DOOR BLOCKING MECHANISM INSTALLATION (XL-40, XL-45 & XL-45E MTH ONLY)

Revision A:

FIGURE 4

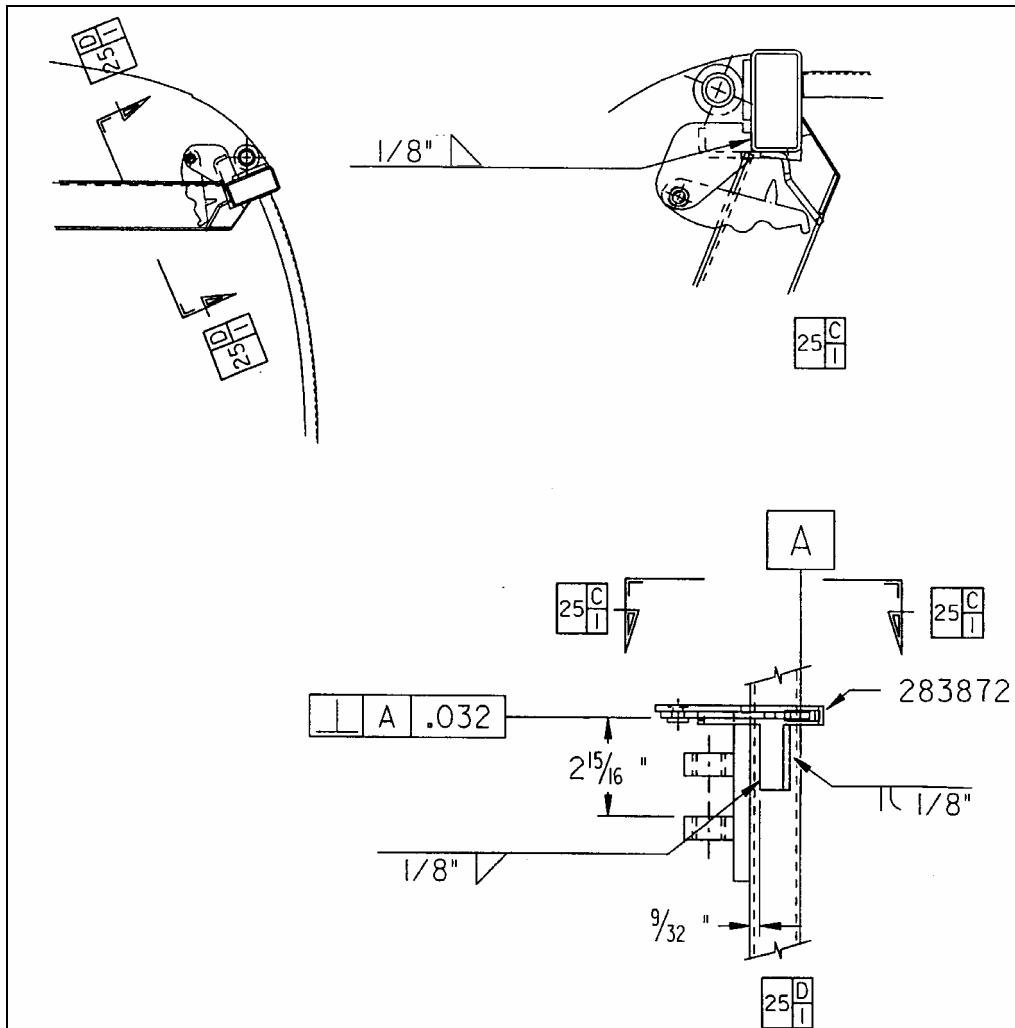
New welding specifications (Figure 4 has been updated).

4. Position and weld (use 308L rod) mechanism at location shown in Figures 3 and 4.
